XL251 Full ESA Approach

- It is ADI's intention to move to a full Electrostatic Actuated (ESA) measurement of Sensitivity
- This change is in keeping with ADI's long term test strategy and in keeping with ADXL251 original Safe Launch plan
- This change is in keeping with ADI's long term supply strategy
- This PCN applies to ADXL251 ONLY

X-axis

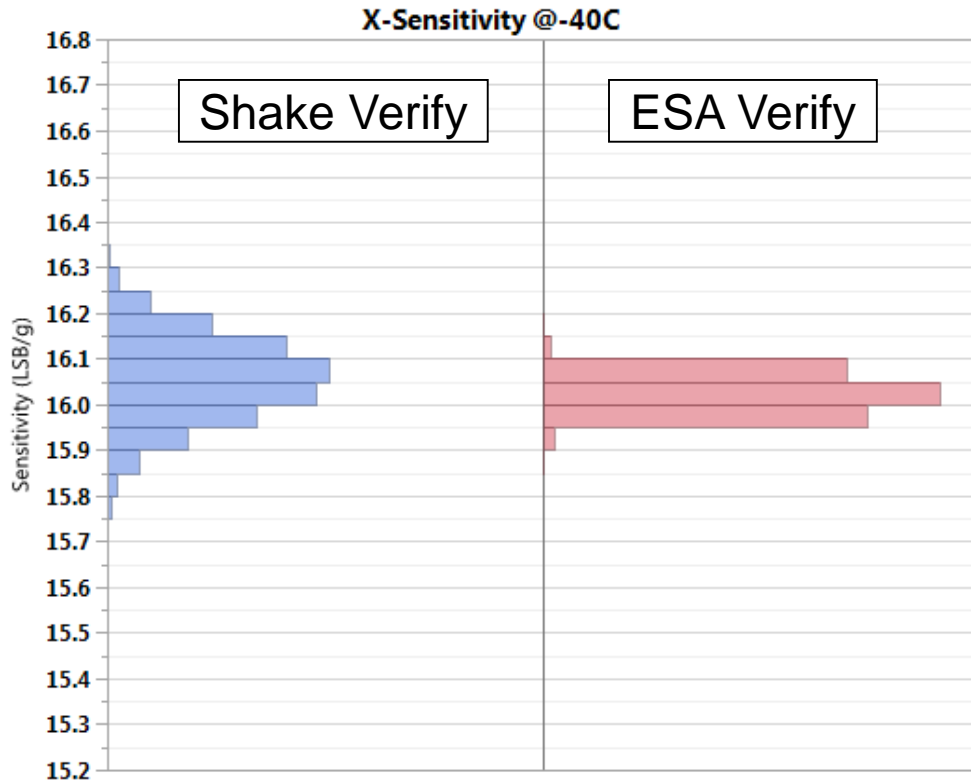
-40C	Mean	Sigma	Cpk
ESA	16.02	0.04	6.5
Shake	16.05	0.09	2.78

Y-axis

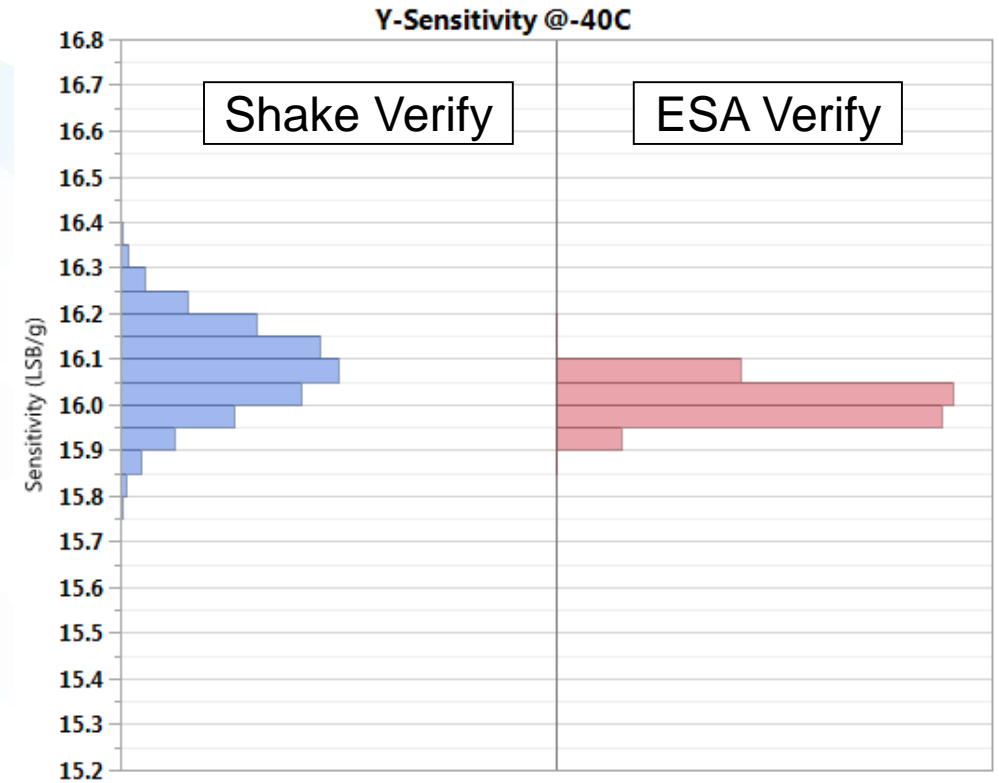
-40C	Mean	Sigma	Cpk
ESA	16.00	0.04	6.67
Shake	16.08	0.09	2.67
